# Riverside Energy Park

## Applicant responses to ExA First Written Questions

**EN010093**

**8.02.04**

Figure 2.1: Predicted NO<sub>x</sub> concentrations from river vessel (Port of London Authority)

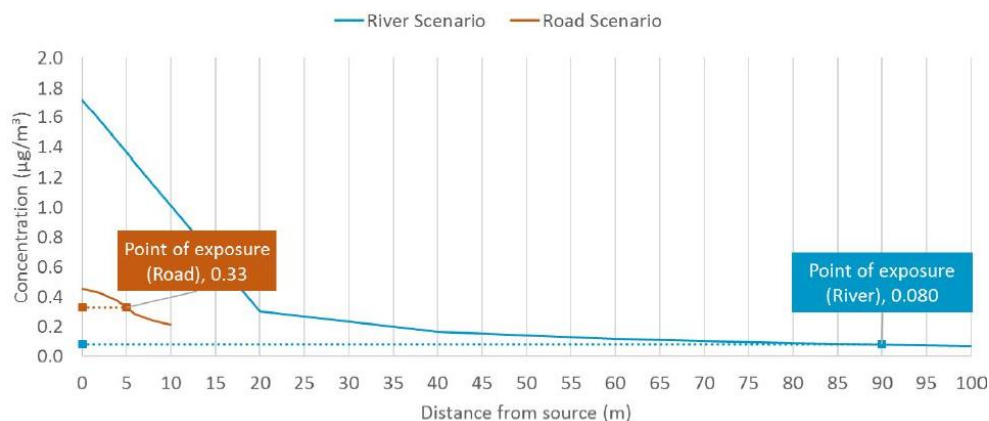
### 2.6.1 Written Question Q2.0.6 states:

2.6.2 The NO<sub>x</sub> concentration of 0.08µg/m<sup>3</sup> reported at **Paragraph 7.9.16 of Chapter 7 Air Quality** of the **Environmental Statement (ES) (6.1, Rev 1)** is taken directly from the Port of London Authority (PLA) Air Quality Strategy for The Tidal Thames updated in June 2018 and represents the predicted NO<sub>x</sub> concentration at a distance of 90m from a vessel on the River Thames with emissions corresponding to Tier II controls (emissions standards for vessels constructed after 1st January 2011).

2.6.3 The distance of 90m is the minimum exposure distance to a residential property as a result of vessel movements on the river (residential receptors are worst-case receptors for the consideration of impacts of NO<sub>x</sub> emissions). The reduction in pollutant concentration with distance can be seen in the following graph in **Figure 2.1** (which is Figure 2 – comparison of NO<sub>x</sub> exposure from river and road sources (scenario 1) taken from PLA's Air Quality Strategy for The Tidal Thames. As a point of comparison, the width of the River Thames at the existing Riverside Resource Recovery Facility (RRRF) is approximately 700m.

2.6.4 The NO<sub>x</sub> concentration from the existing vessels on the river was used to estimate the increase in pollutant concentrations at receptor locations along the river due to the increase in vessel movements as a result of REP (see response to ExA Q2.0.7).
